FINAL
ENVIRONMENTAL IMPACT REPORT
CITY OF LOS ANGELES

City of Los Angeles Mobility Plan 2035
Case Number: ENV 2013-0911-EIR
RELATED CASE Number CPC-2013-0910-GPA-SP-CA-MSC
State Clearinghouse No. 2013041012

May 2015

FIGURE 3-3

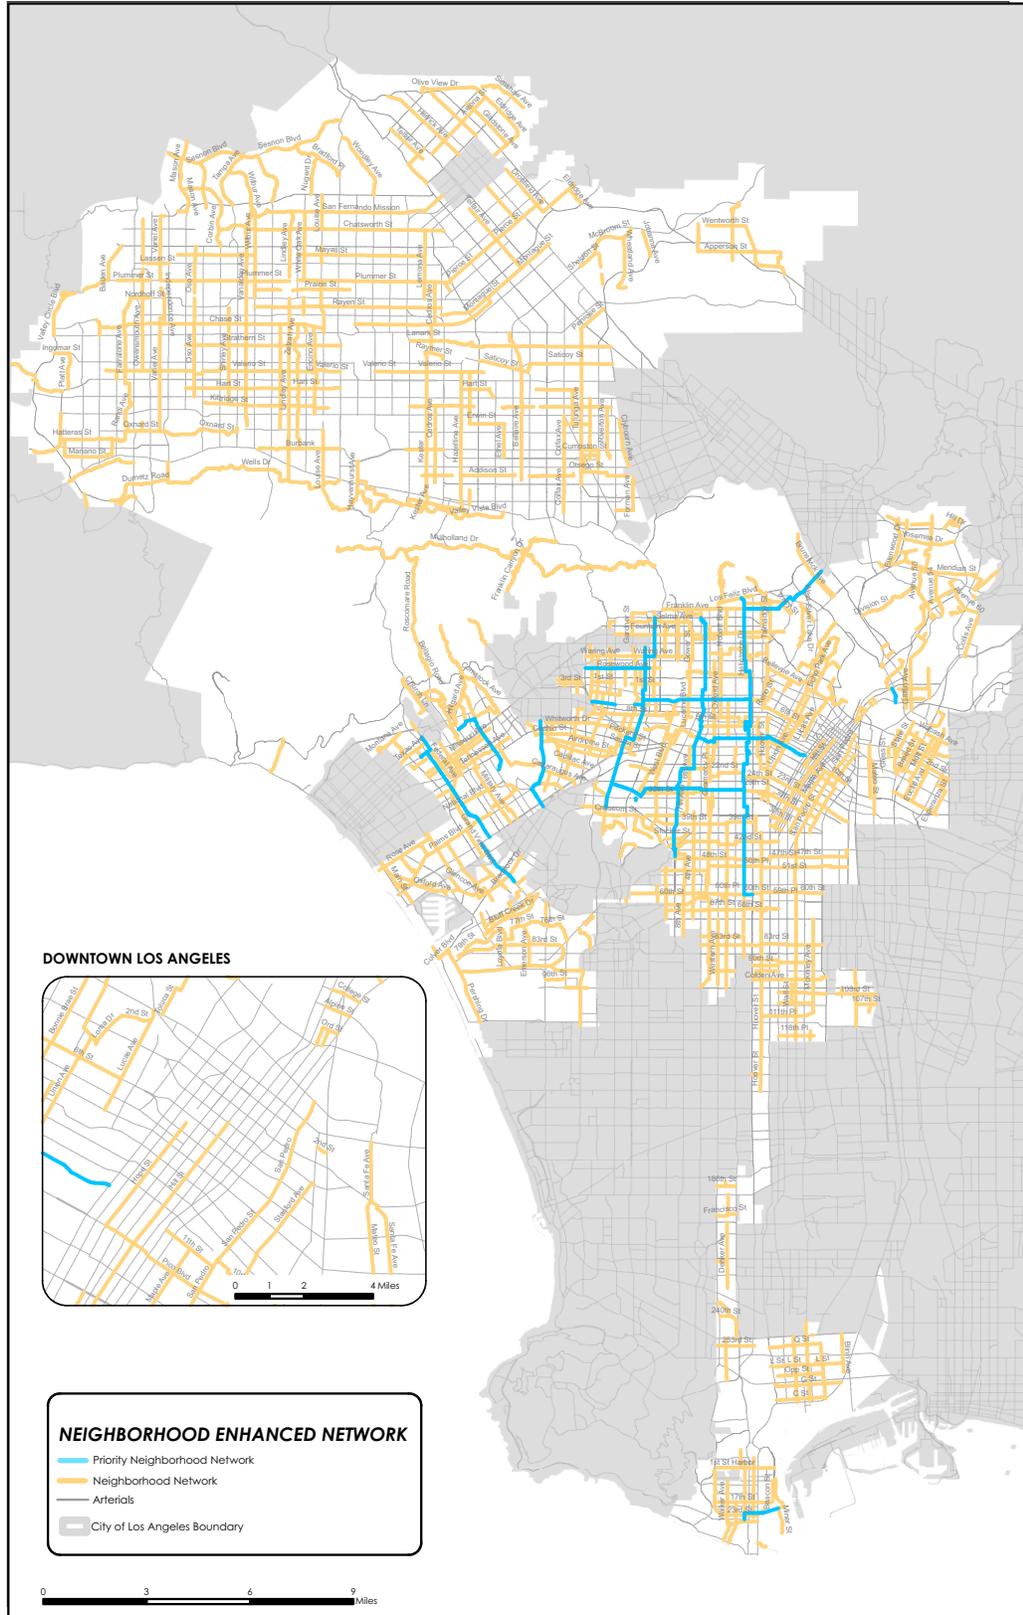
See comment below. Fig 3-3 shows Hyperion as it crosses the river as part of the BEN, but the table on page 3-7 lists only Fletcher, not Hyperion.

FIGURE 3-4A

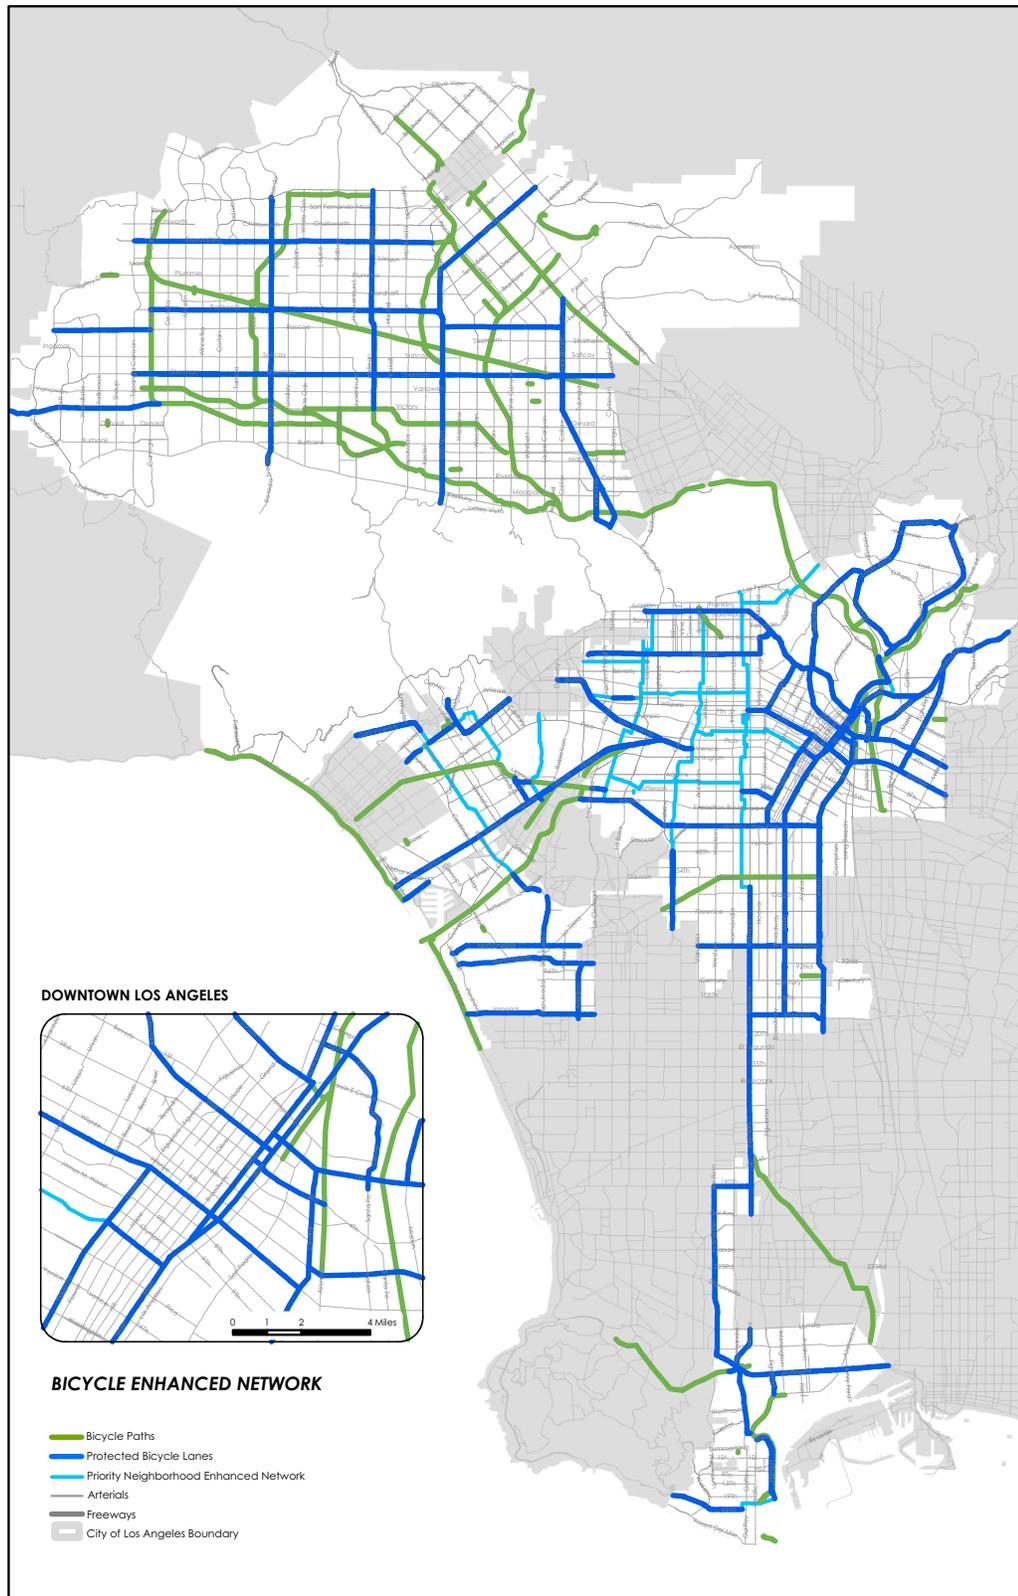
13. *Figure 3-4a shows BEN low-stress separated bikeways (class IV/cycle tracks) for Ohio Ave. (Barrington to Westwood)—will this require removing vehicle parking or travel lanes? If so, what impacts will this have?*

The RDEIR contains a figure displaying the updated Bicycle-Enhanced Network Corridors (see **Figure 3-4A**).
